Intel[®] 810E2 Chipset Platform for Use with Universal Socket 370

Design Guide Update

April 2002

Order Number: [298650-002](#)

5) **Changed: Figure 67, Trace Routing, in Section 6.20.2.1, General Trace Routing Considerations.**

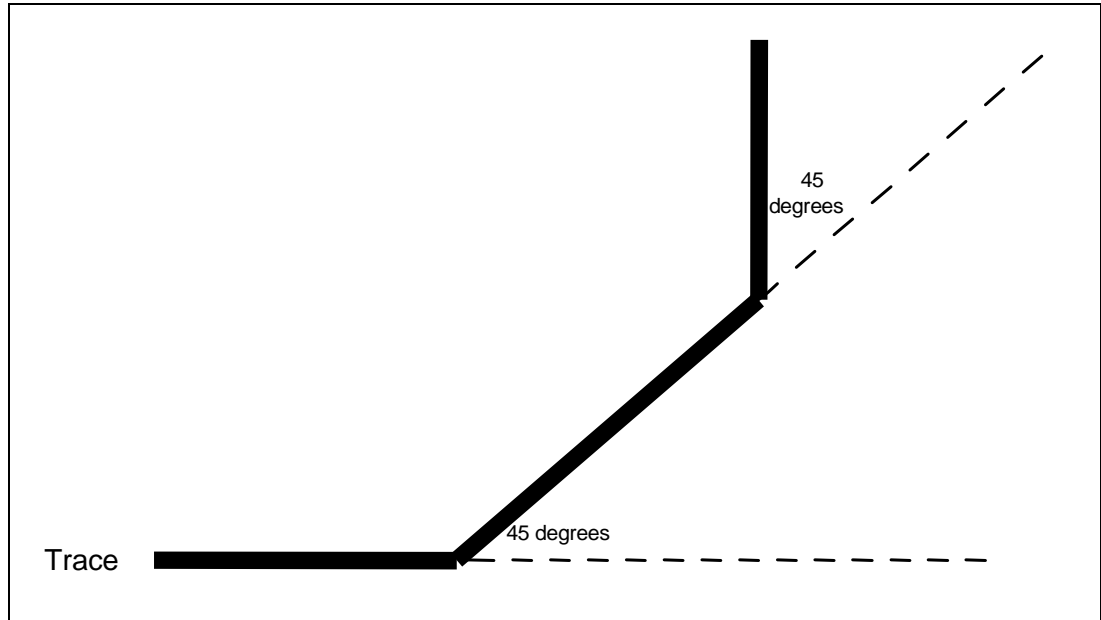
Figure 67, Trace Routing, in Section 6.20..2.1, General Trace Routing Considerations, is replaced with the following figure:

6) **Changed: Figure 61.1-a, RTC Power Well Isolation Control, in Section 6.19.8, Power Well Isolation Control Strap Requirements**

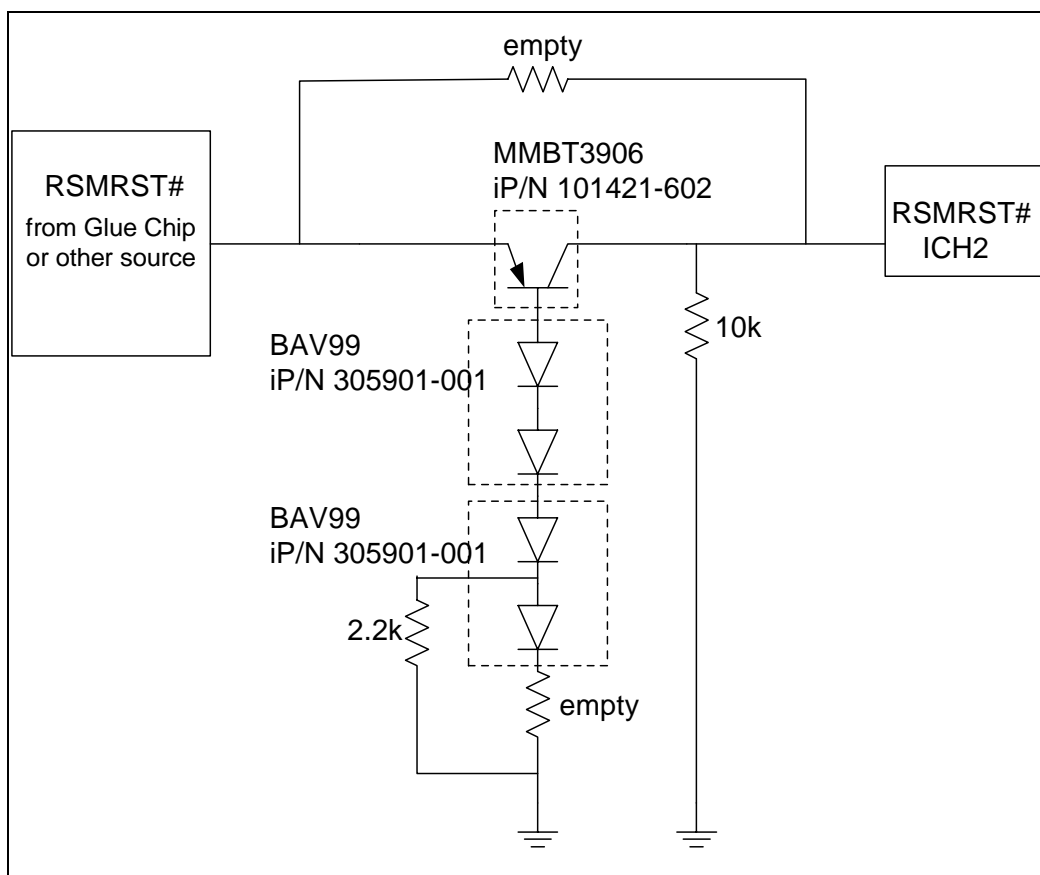
Figure 61.1-a, RTC Power Well Isolation Control, was added by Intel® 810E Chipset Platform for Use With Universal Socket 370 Design Guide Update, dated July 18, 2001, Document Number 298353-001, as document change #1. Figure 61.1-a is now changed to the following:
